REASON FOR UPDATE:

- For applications without a jounce stop
- Installation and fitment requirements

- W217602625 – Ride Rite
- W217602716 – RED Label
- W217602845 – All In One Analog
- W217602854 – All In One Wireless

Applications	
Year	2017-2023
Make	Ford
Models	F250/F350/F450 (4WD)

Diagram 1

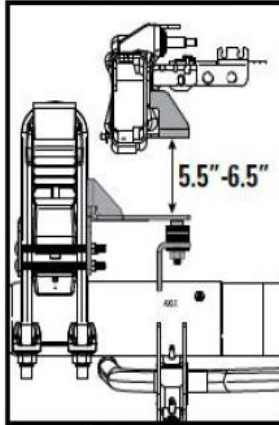
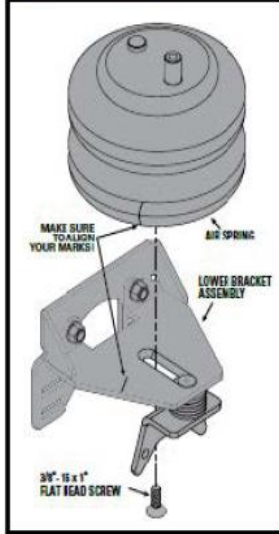
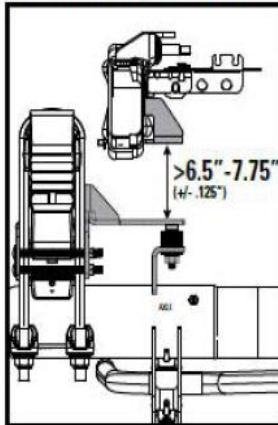
- If utilizing the 1.5” spacer (5336) during the installation of 2625, 2716, 2845, or 2854, install part number 2335820045 inside the spacer to fill the gap between the lower bracket and the spacer.
- Utilizing the puck will not require different hardware to secure the air spring to the lower bracket. See “Diagram 1”.
- If your kit did not come with part number 2335820045, or if you need additional information, please contact tech support at: 800-888-0650 or email rtech@fsip.com.

- When securing the air springs to the lower brackets, use part number 3514 (1.0” Flat Head Cap Screws) when the 1.5” spacer (5336) is **not** being used.
- When using the 1.5” spacer (5336), use part number 3430 (2.0” Flat Head Cap Screws) to secure the air spring to the air springs to the lower brackets.

Diagram 2

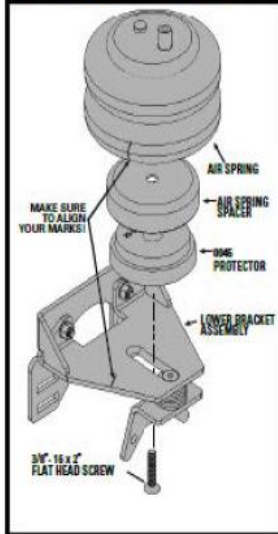
- See Diagram 2 for proper installation of the axle extension bracket. If there is no jounce stop installed, the axle extension bracket must be used in those applications.
